To: All Plan Holders **Project:** Department of Public Safety (DPS) Hangar
Airport: South Texas International Airport at Edinburg **KSA Project No.:** EDN.024
Date: May 17, 2017 **Client Project No.:** TxDOT CSJ No. 16HGEDNBG

Addendum No. 2 Issued By:

“Department of Public Safety (DPS) Hangar”

SHEET NUMBER
ADD.-2.2

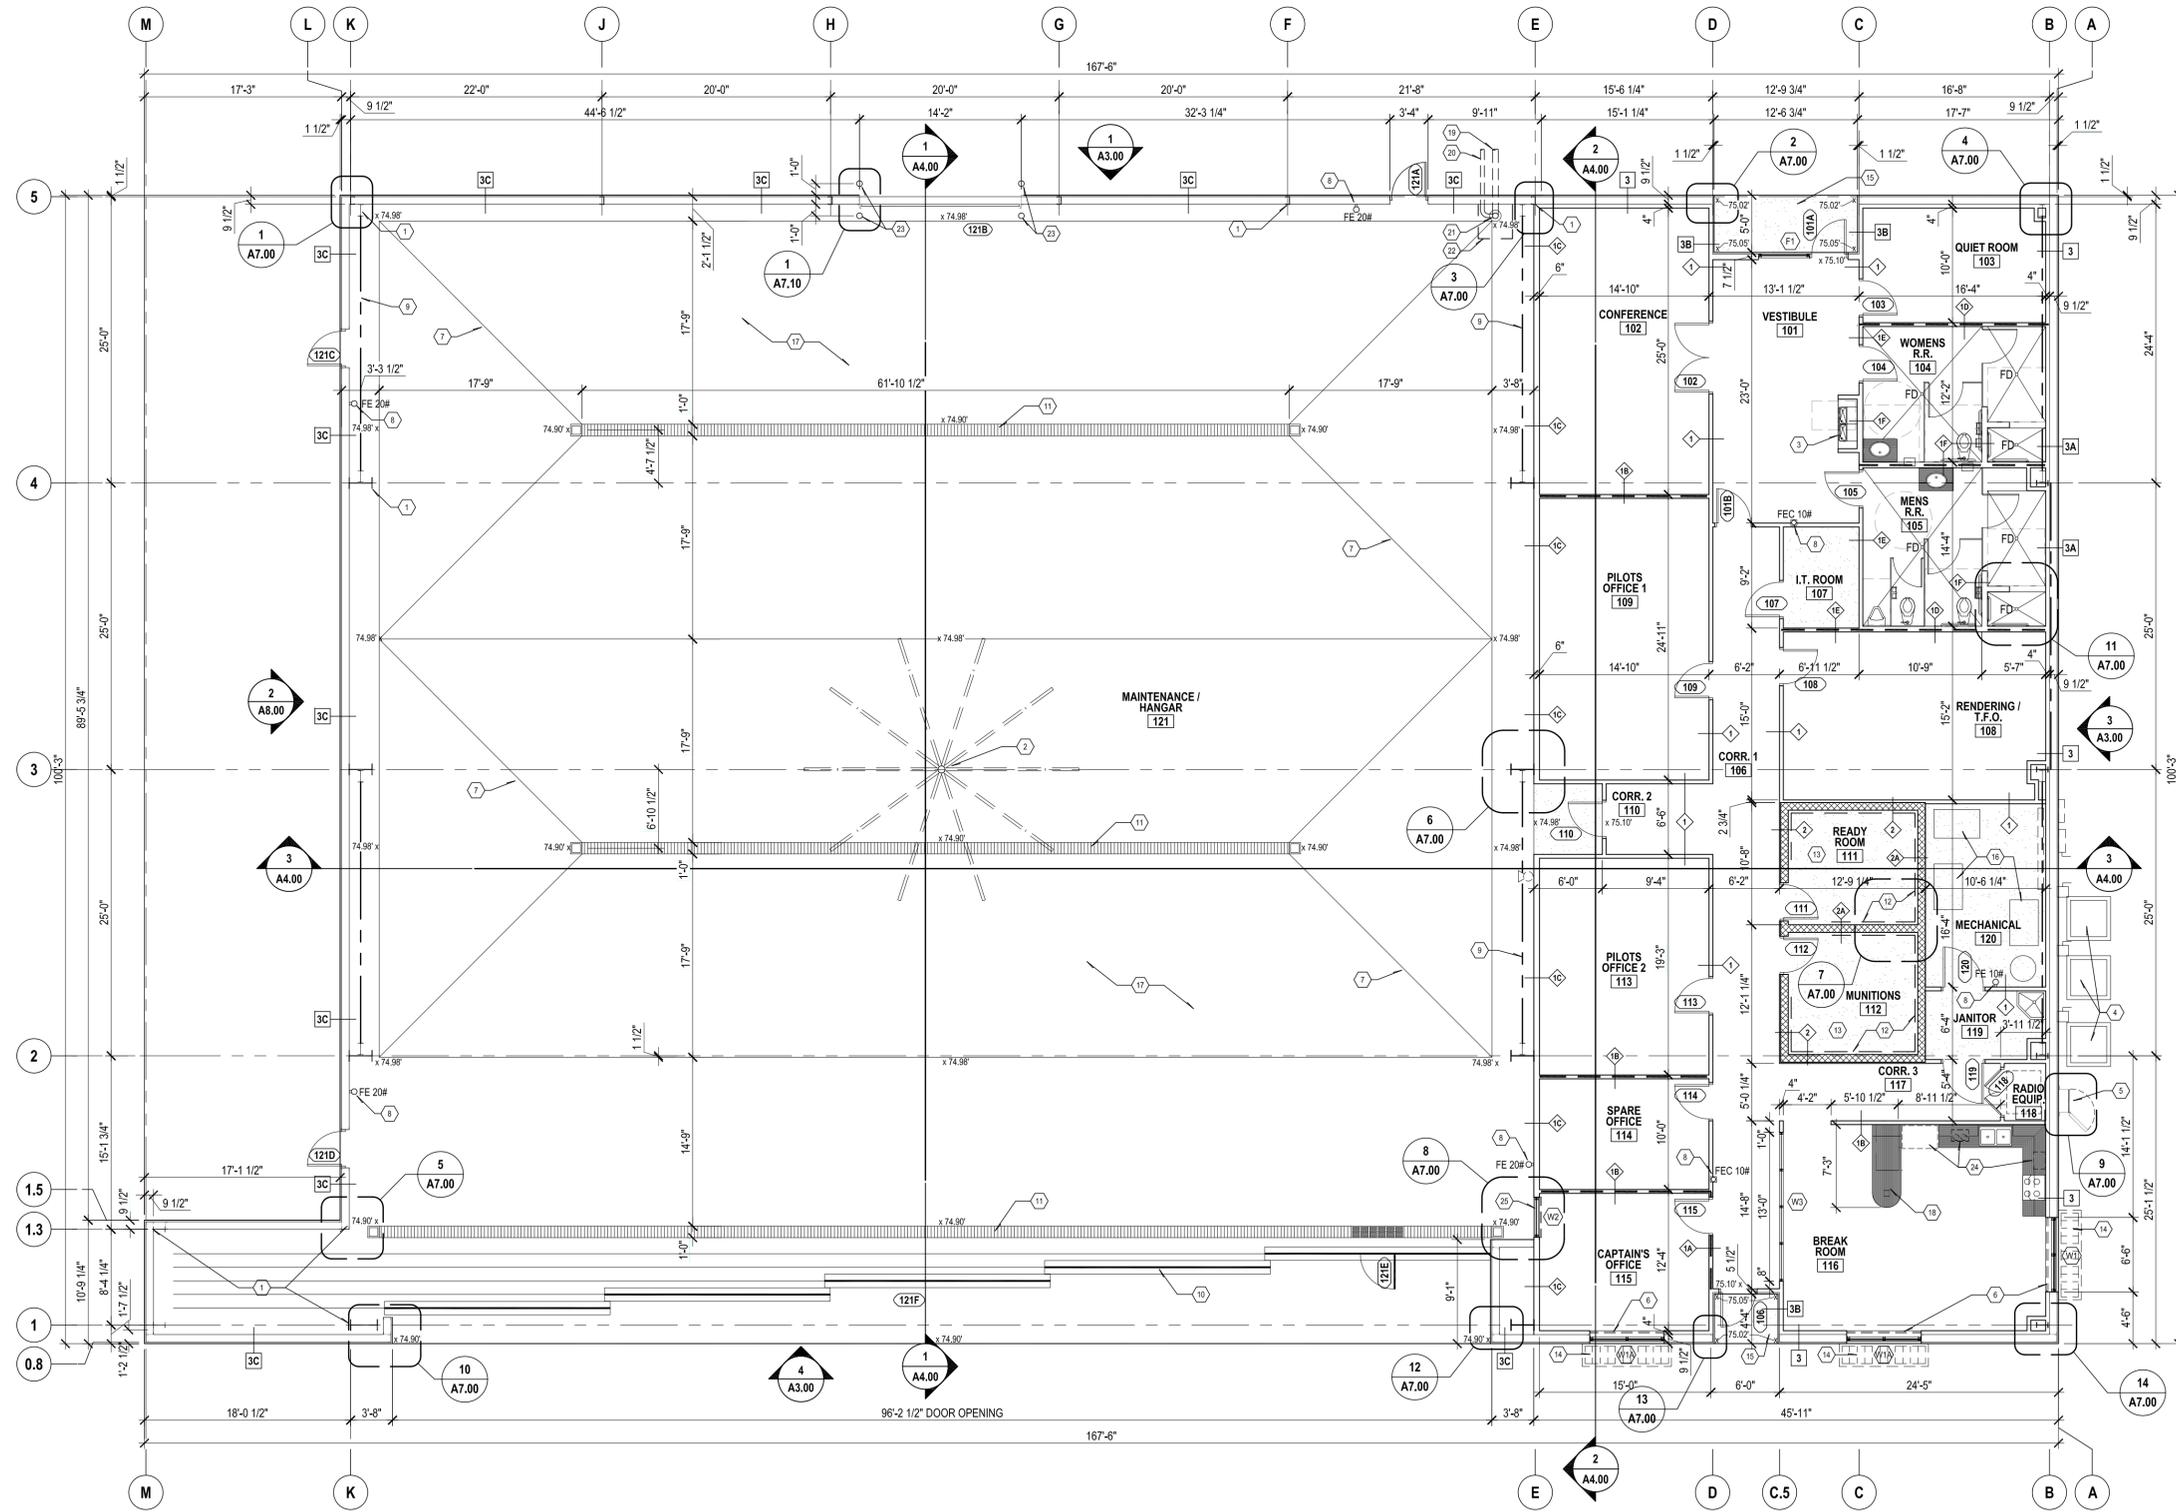
- 2-7 Sheet A2.10 – See attached Sheets ADD2.1 & ADD2.2 which are enlarged and revised schedules which replace those shown or originally issued Sheet A2.10.
